Document Reference	IC02-INT-EC-OFL-001-INC-RPT-003	Revision	0
Date	22 November 2022		
Date of Next Review	N/A		
Classification	Public

Inch Cape Offshore Wind Farm Section 36 Variation Application Report

Figure 2.1: Illustration of a 'Grid' Configuration

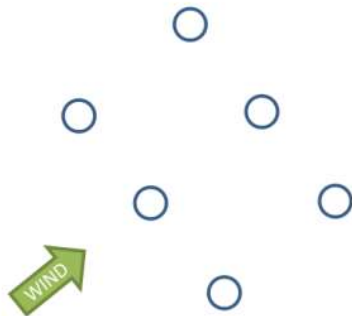
11 Layout is not specified in the Section 36 Consent (or Marine Licence) but was anticipated to be a grid or offset grid configuration (Figure 2.1, Figure 2.2). The Original Development included 213 WTGs with a nominal minimum spacing of 820 m as the worst case, while the Revised Development encompassed 72 WTGs with a nominal minimal spacing of 1,278 m.

14 Recent site geotechnical data has been collected for 80 potential WTG locations, of which 72 locations will be chosen for WTG placement, arranged in an optimised border layout. This would result in an increase in WTGs around the border of the Development Area, with the remaining WTGs arranged in a grid in the centre of the Development Area, and a change of the minimum spacing to 1,025 m. A variation is required to change the nominal WTG spacing of 1,278 m in Marine Licence 06781 and Section 36.
